**STAFF RECOMMENDATION**

**1101 Halcyon Avenue**

**January 20, 2021**

**Application:** New Construction—Addition; Setback determination

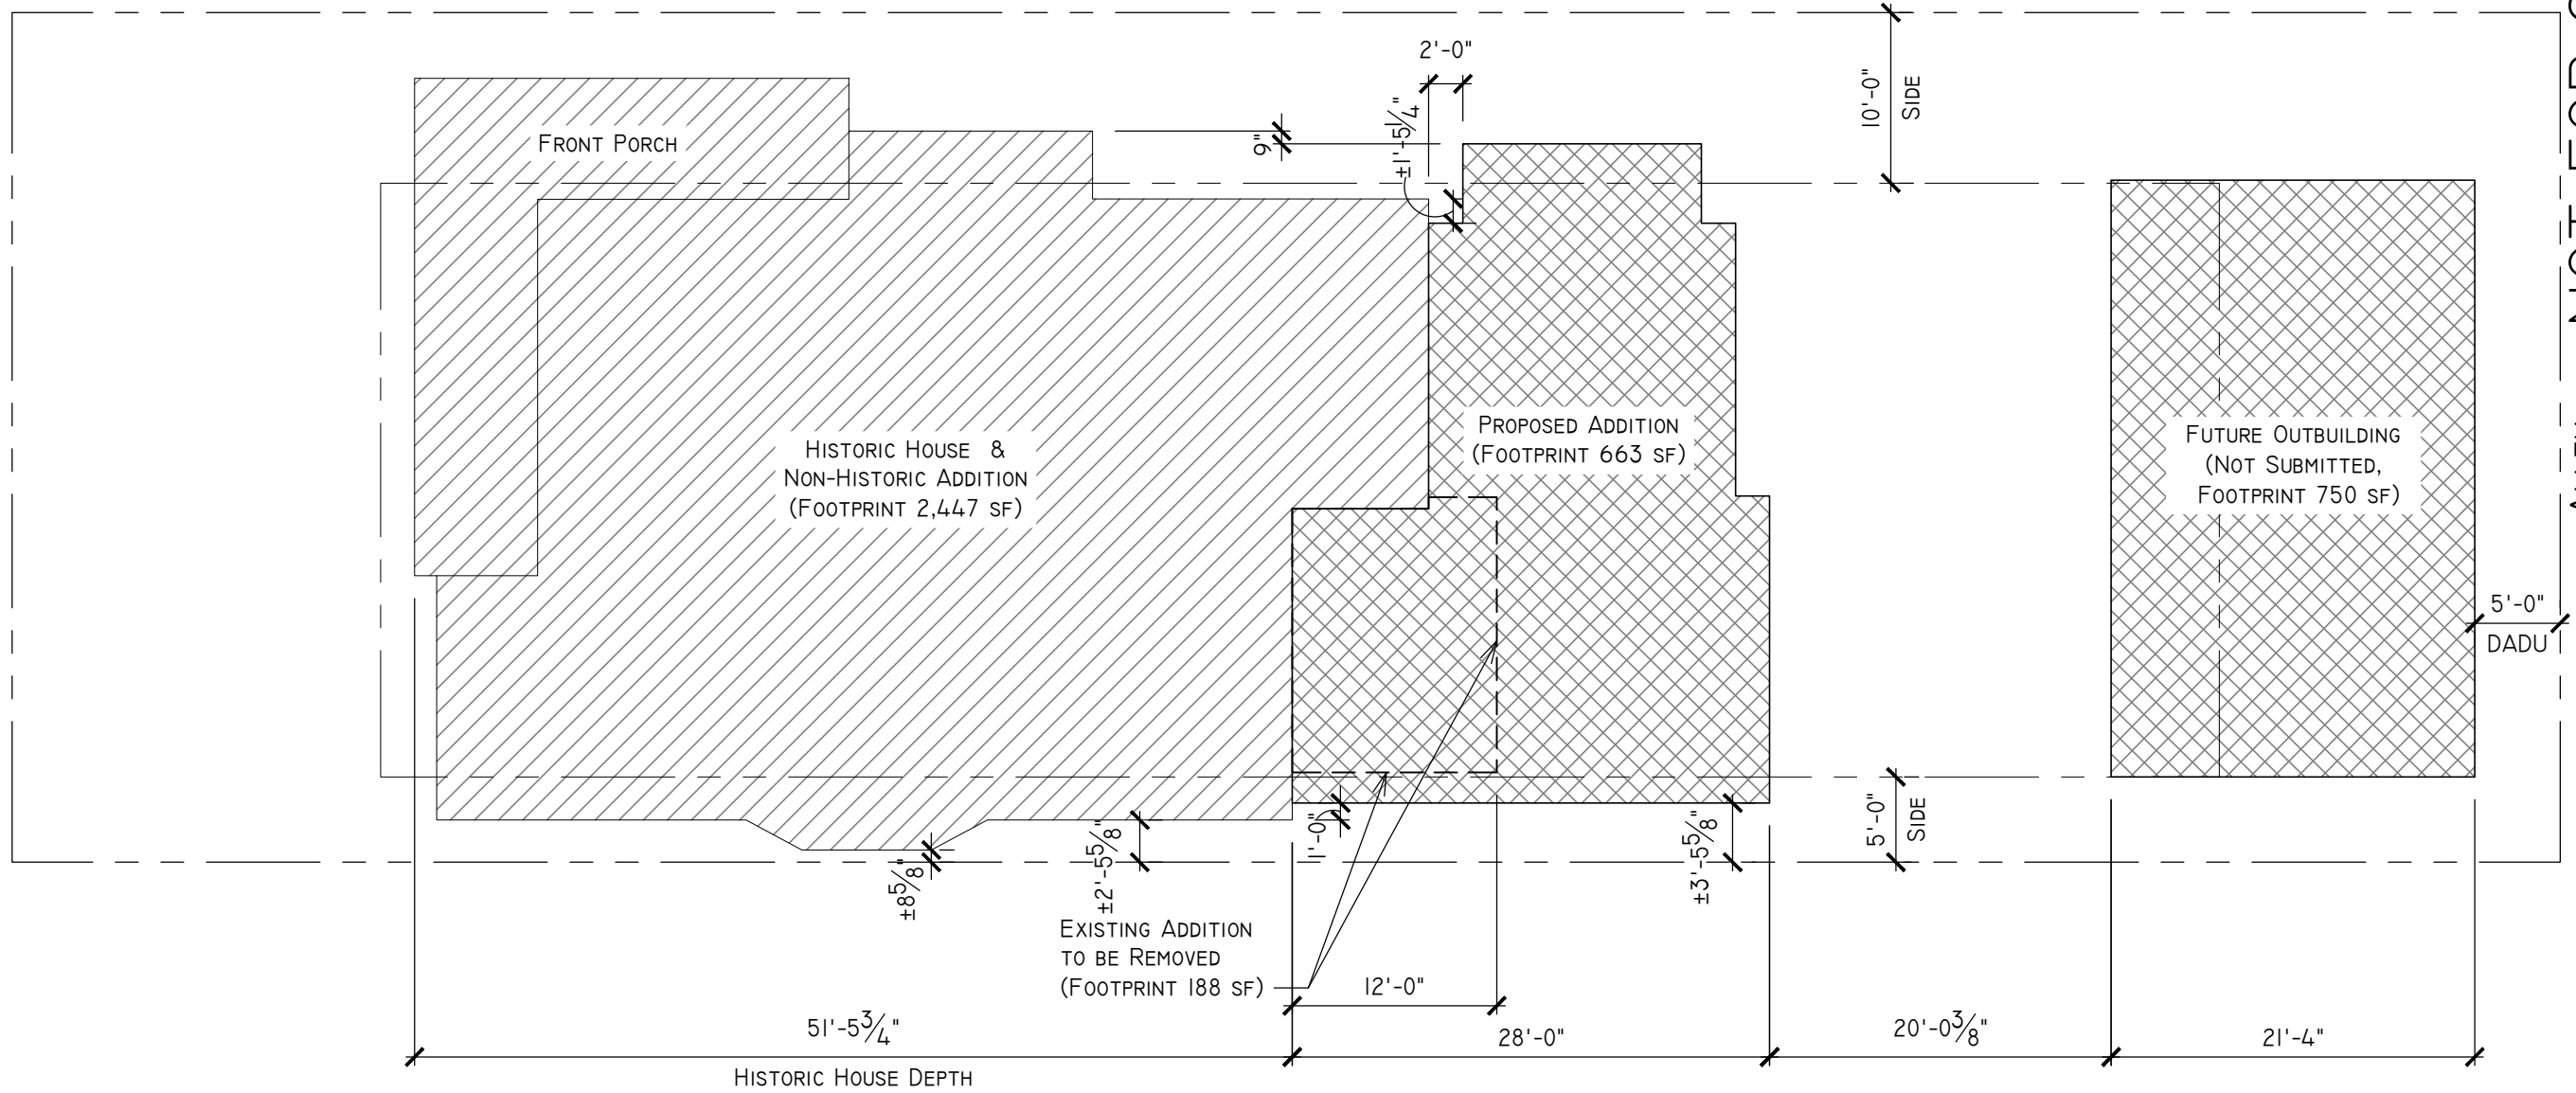
Proportion and Rhythm of Openings: No changes to the existing windows or doors were indicated on the plans. The windows on the proposed addition are all generally twice as tall as they are wide, thereby meeting the historic proportions of openings. There are no large expanses of wall space without a window or door opening.

Staff finds the project's proportion and rhythm of openings to meet Sections III.G. and IV. of the design guidelines.

**ARCHITECTURAL SITE PLAN**

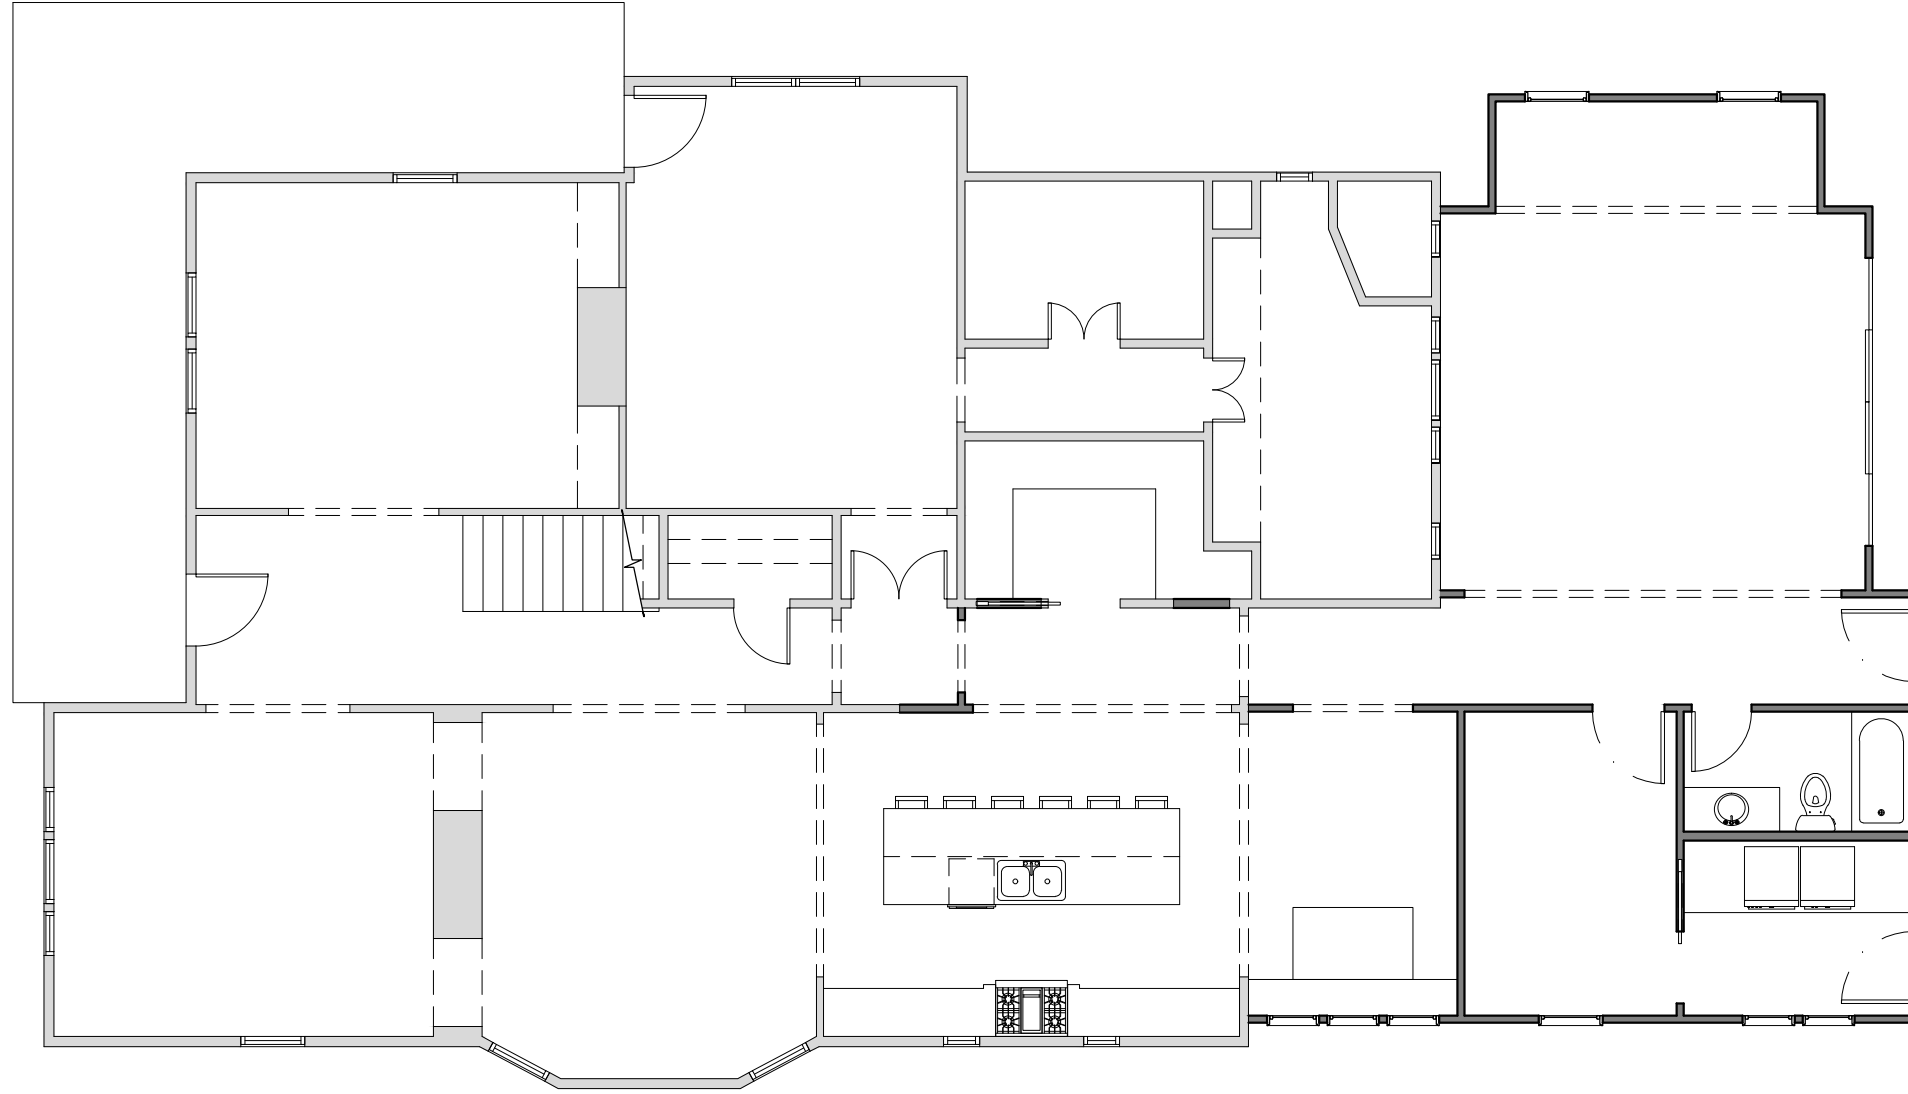
Setback & Rhythm of Spacing: The addition does not meet the base zoning setbacks on either side property line. There is a required ten foot (10') side setback from the 11<sup>th</sup> Avenue South side property line and a five foot (5') setback from the interior side property line. The application proposes a seven feet, seven inch (7'7") setback from the 11<sup>th</sup> Avenue South property line and a three feet, six inch (3'6") setback from the interior side property line. Staff finds both of these proposed side setbacks to meet the design guidelines because in both cases, the historic house does not meet the side setbacks. The addition will not be any wider than the historic house and will, in fact, be narrower than the historic house. In addition, the addition's depth is not overly large with a maximum depth of twenty-eight feet (28'). The addition will be approximately forty-six feet (46') from the rear property line, which meets the base zoning setback.

Staff finds that the proposed setbacks and rhythm of spacing to meet Sections III.C. and IV. of the design guidelines.

EXTERIOR ELEVATIONS

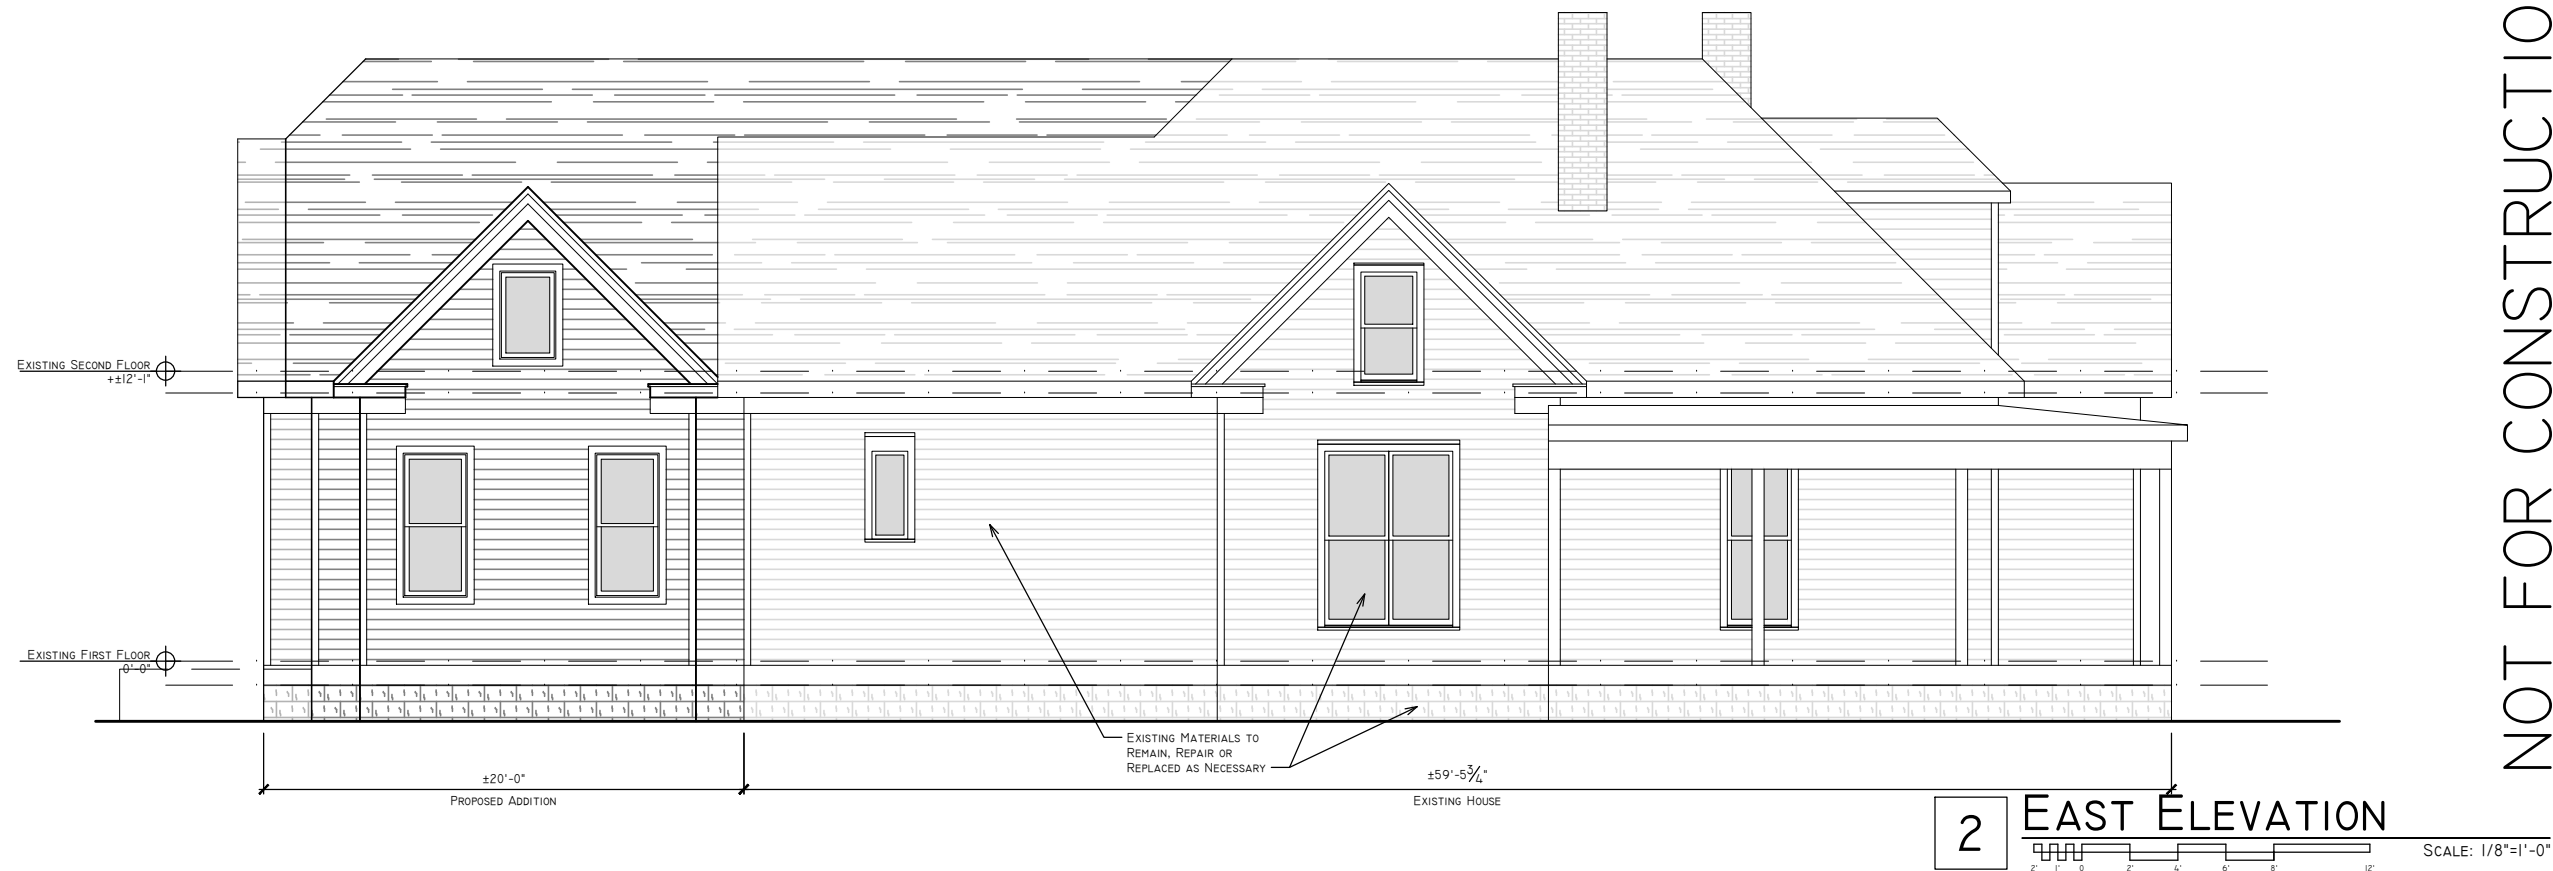
Height & Scale: The addition is one-and-half-stories in height, matching the scale of the historic house. The addition's foundation, eaves, and ridge heights all match those of the historic house. On the right side, the addition will be inset one foot (1') from the back corner of the house for its entire depth. On the left side, the addition will be inset approximately eighteen inches (18") for a depth of about two feet (2'), after which there is a one-story bay that steps back out almost to the line of an existing side bay on the historic house.

Roof form: The addition's roof form will be a combination of hipped and gable forms that are similar to the hipped and gable forms found on the historic house. The applicant proposes a side dormer on the historic portion of the roof, right façade. This hipped dormer is offset from the ridge of the roof and is inset at least two feet (2') from the wall below. It is similar in size and scale to the dormer on the house's front façade and meets the design guidelines for side dormers. There are two similar dormers on the right side of the addition that are inset two feet (2') and are scaled to meet the design guidelines. Staff finds that these roof forms are all compatible with the historic house's roof form.

Overall, staff finds that the addition's height and scale to meet Sections III.A., III.B., and IV.B. of the design guidelines.

Staff finds that the proposed roof forms meet Sections III.E. and IV.C of the design guidelines.
